AMENDMENTS TO THE DRAWINGS

REMARKS

These remarks and the accompanying amendment are responsive to the Office Action made final and dated September 15, 2005 (hereinafter, the "Office Action"). Claims 2-5, 7-26 and 28-48 were pending at the time of the last examination. By this amendment, Claims 16 and 17, leaving Claims 2-5, 7-26 and 28-48 still pending. Reconsideration and allowance for the above-identified application are now respectfully requested in light of these remarks and the accompanying amendments.

FIG.1

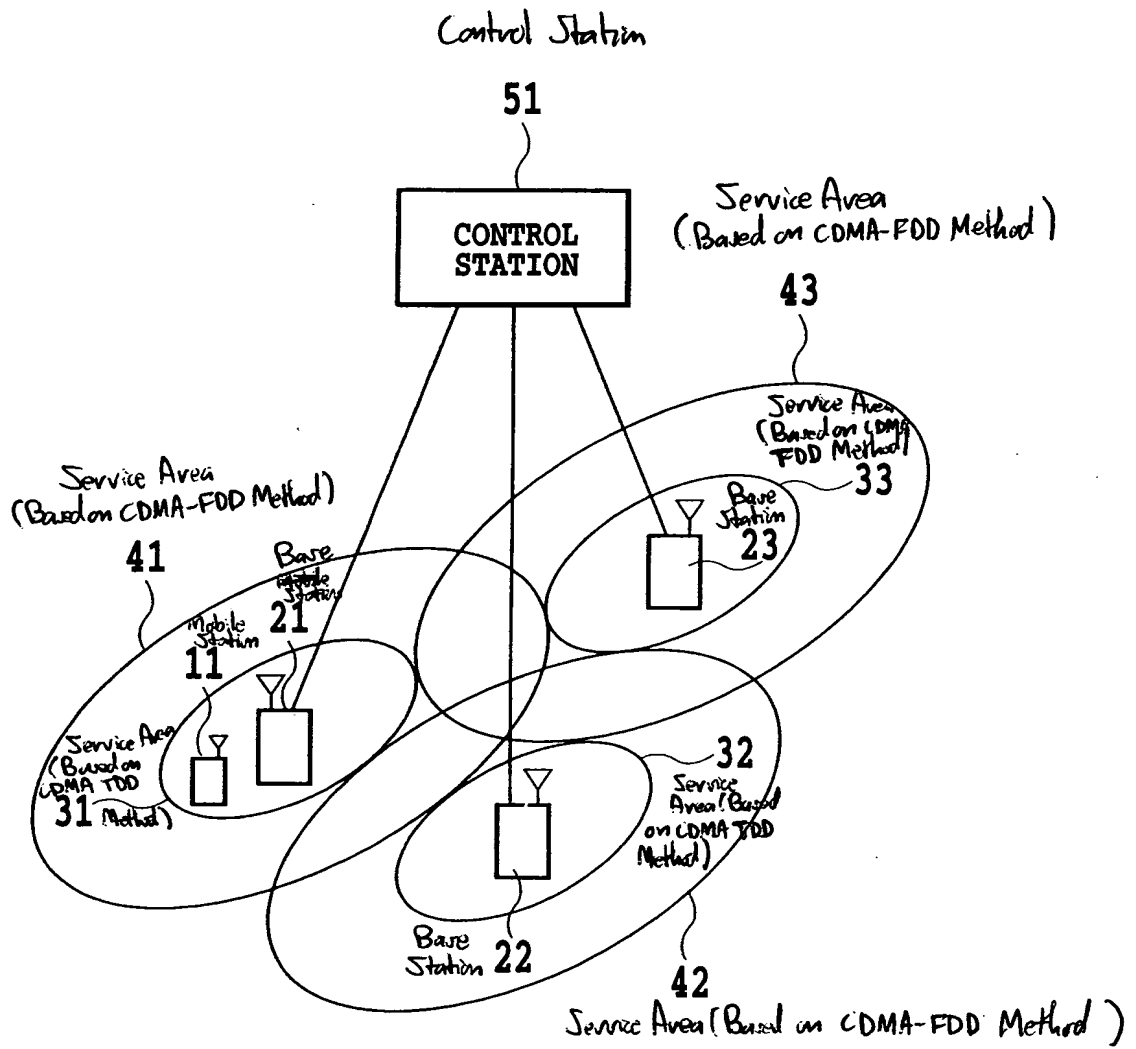
Section 2 of the Office Action objected to the drawings indicating that all blocks in the Figures 1 and 3-7 should be labeled with descriptive legends. The drawings are amended herein to include descriptive legends.

The attached sheets of drawings include changes to sheets 1/9, 3/9, 4/9, 5/9, 6/9 and 7/9. These sheets, which includes Figure 1 and 3-7, replaces the original sheets 1/9, 3/9, 4/9, 5/9, 6/9 and 7/9, respectively, including Figures 1 and 3-7.
